ADDENDUM 1

CITY OF FAIRHOPE

Bid 034-20 Masonry and Concrete Work for Alterations to FH Municipal Stadium

Bid No/Name: 034-20 Masonry and Concrete Work for Alterations to Fairhope Municipal Stadium
Project No./Name:REC002-20 ADA Alterations to FH Stadium

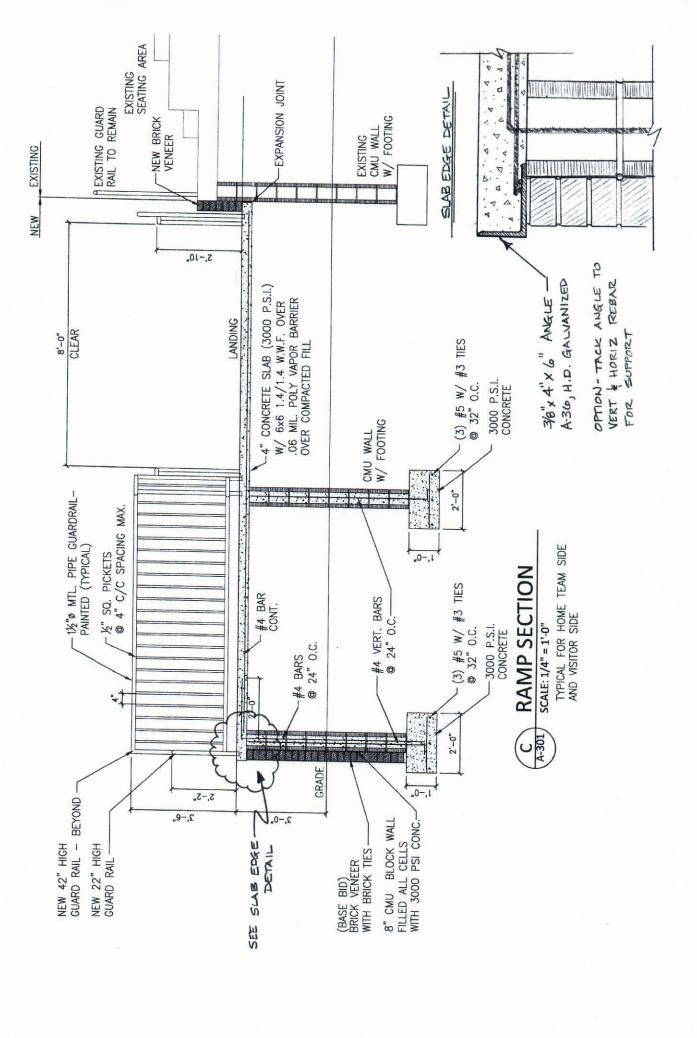
This added alternative is to install a $3/8 \times 4 \times 6$ Angle (A-36, hot-dipped galvanized) as a slab edge treatment at all leading edges of the exposed slab (viewing platforms). Contractor shall determine the best means and methods to support and secure angle during concrete placement and curing. Detail attached.
